## **WILDWOOD GLEN SUBDIVISION, RESUBDIVISION OF LOT 1**

APPLICATION NUMBER 5 DATE April 15, 2021  
APPLICANT Wildwood Glen Subdivision, Resubdivision of Lot 1  
REQUEST Subdivision

# DETAIL SITE PLAN

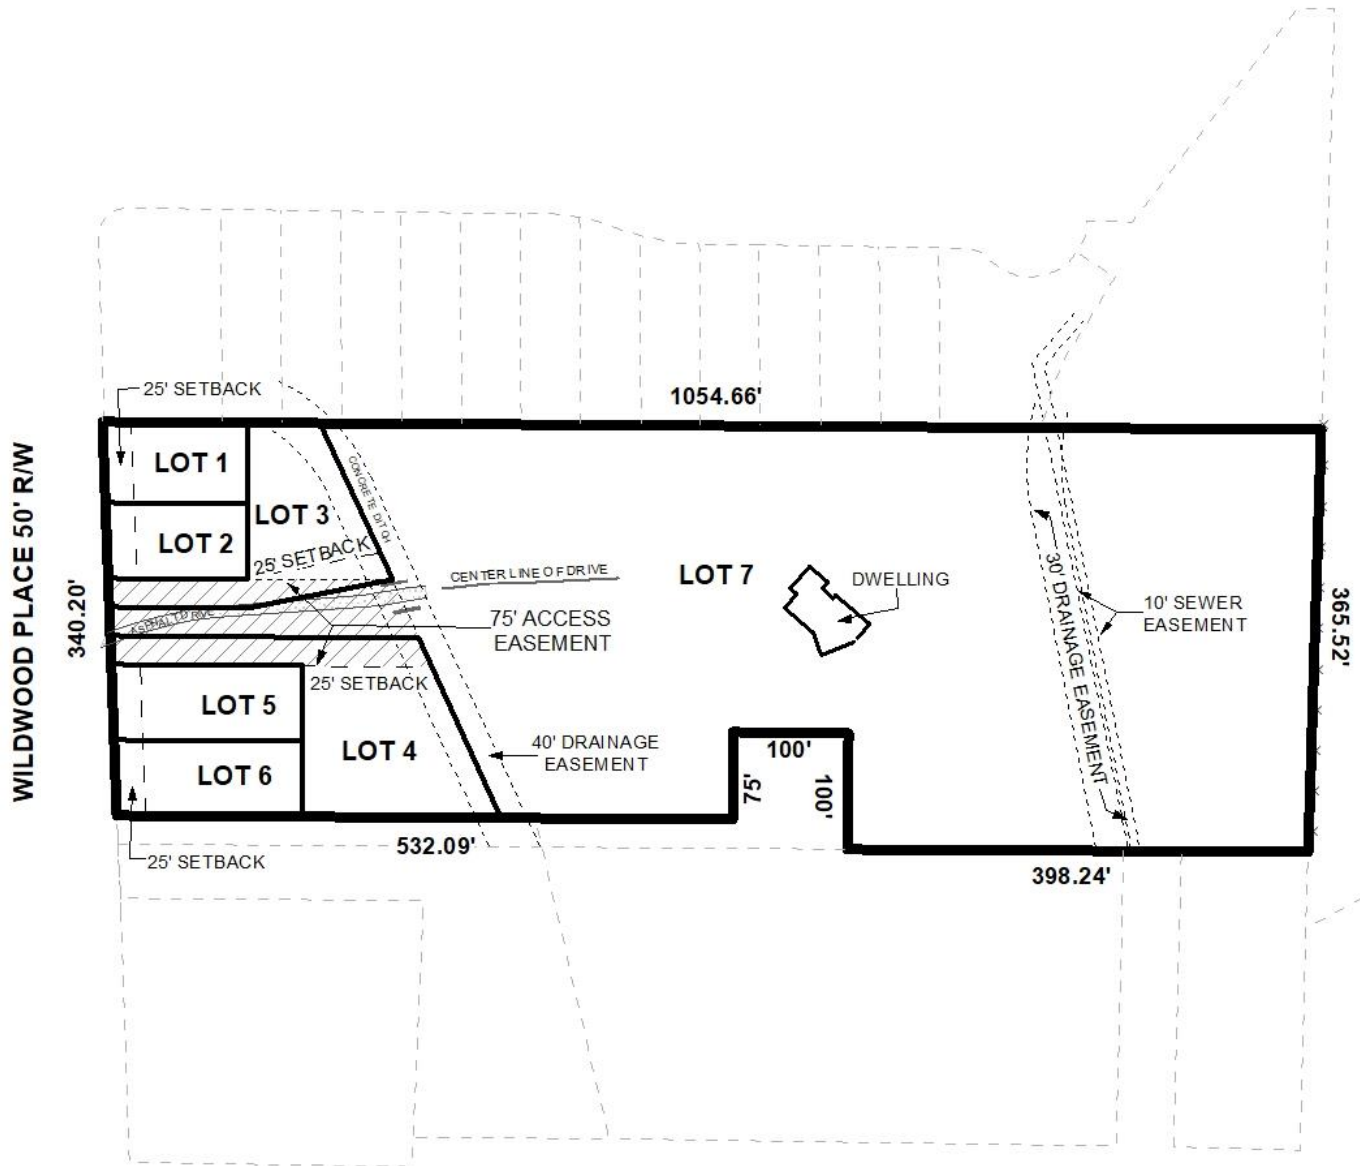
The site has frontage along Wildwood Place, a minor street with curbs and gutters and a compliant 50' right-of-way; therefore, no dedication would be required. The right-of-way width of Wildwood Place should be retained on the Final Plat, if approved. Proposed Lot 7 also has an unopened portion of Panorama Drive stubbing into its South side in the rear portion of the property. As this is not indicated on the preliminary plat, the plat should be revised to indicate this street stub on the Final Plat with its right-of-way width.

As on the preliminary plat, the lot size labels in both square feet and acres should be retained on the Final Plat, or a table should be furnished on the Final Plat providing the same information.

Proposed Lots 1, 2, 5 and 6 would be standard lots fronting Wildwood Place. As proposed, Lots 3, 4 and 7 are flag lots. Section V.D.1. of the Subdivision Regulations generally prohibits flag lots, but exceptions can be made in instances where other such lots are in the vicinity. In this instance, adjacent Lot 2, Wildwood Glen Subdivision, was approved as a flag lot, and adjacent to that to the South, Wimberly Subdivision, Second Addition, was approved as a flag lot subdivision. Therefore, a waiver of Section V.D.1. would seem in order.

Lots 3, 4, and 7 are proposed to have a common non-exclusive easement for ingress and egress spanning the 75-foot width of the combined "poles". As this area cannot be considered as buildable site area, a note should be required on the Final Plat stating that no structures shall be constructed or placed within this particular easement.

As Lots 3 and 4 would have only the minimum-required 25 feet of public street frontage, a note should be required on the Final Plat stating that there shall be no further subdivision of those lots

until additional public street frontage is provided. Lot 7 would have the minimum-required 25 feet of public street frontage along Wildwood Place, and would have 50 feet of frontage at the North end of the unopened Panorama Drive street stub. Therefore, a note should be required on the Final Plat stating that there shall be no further subdivision of Lot 7 until the unopened portion of Panorama Drive is developed to City street standards.

As on the preliminary plat, the 25-foot minimum building setback line for Lots 1, 2, 5 and 6 should be retained along Wildwood Place on the Final Plat. The plat should be revised to indicate a 25-foot minimum building setback line for Lot 7 blocked-out at the North terminus of Panorama Drive.

The preliminary plat indicates a 25-foot minimum building setback line for Lots 3 and 4 as measured from the “poles” of those lots. However, the setback line should be revised for Lots 3 and 4 as measured from where the lots are at least 60 feet in width. No minimum building setback line is indicated along the front of Lot 7. The plat should be revised so as to indicate a 25-foot minimum building setback line for Lot 7 spanning the width of the lot as measured from the rear of Lots 3 and 4.

The plat indicates two large City of Mobile drainage easements and one sanitary sewer easement crossing the property. Therefore, a note should be required on the Final Plat stating that no structures shall be constructed or placed within any easement without permission of the easement holder.

As per the Traffic Engineering comments, Lots 3, 4 and 7 are limited to one shared curb cut; Lots 1, 2, 5 and 6 are limited to one curb cut each. Driveway size, location and design to be approved by Traffic Engineering and conform to AASHTO standards. A note should be placed on the Final Plat stating these comments.

- 1) retention of the right-of-way width of Wildwood Place on the Final Plat;
- 2) revision of the plat to indicate the unopened street stub of Panorama Drive, with its current right-of-way width, on the Final Plat;

- 3) retention of the lot size labels in both square feet and acres on the Final Plat, or the furnishing of a table on the Final Plat providing the same information;

- 4) placement of a note on the Final Plat stating that no structures shall be constructed or placed within the common non-exclusive easement for ingress and egress for Lots 3, 4 and 7;

- 5) placement of a note on the Final Plat stating that there shall be no further subdivision of Lots 3 and 4 until additional public street frontage is provided for those lots;

- 6) placement of a note on the Final Plat stating that there shall be no further subdivision of Lot 7 until the unopened portion of Panorama Drive is developed to City street standards;

- 7) retention of the 25-foot minimum building setback line for Lots 1, 2, 5 and 6 along Wildwood Place on the Final Plat;
- 8) revision of the plat to illustrate the 25-foot minimum building setback line for Lot 7 blocked-out at the North terminus of Panorama Drive;

- 9) revision of the plat to illustrate the 25-foot minimum building setback for Lots 3 and 4 as measured from where the lots are at least 60 feet wide;

- 10) revision of the plat to indicate a 25-foot minimum building setback line for Lot 7 spanning the width of the lot as measured from the rear of Lots 3 and 4;

- 11) placement of a note on the Final Plat stating that no structures shall be constructed or placed within any easement without permission of the easement holder;
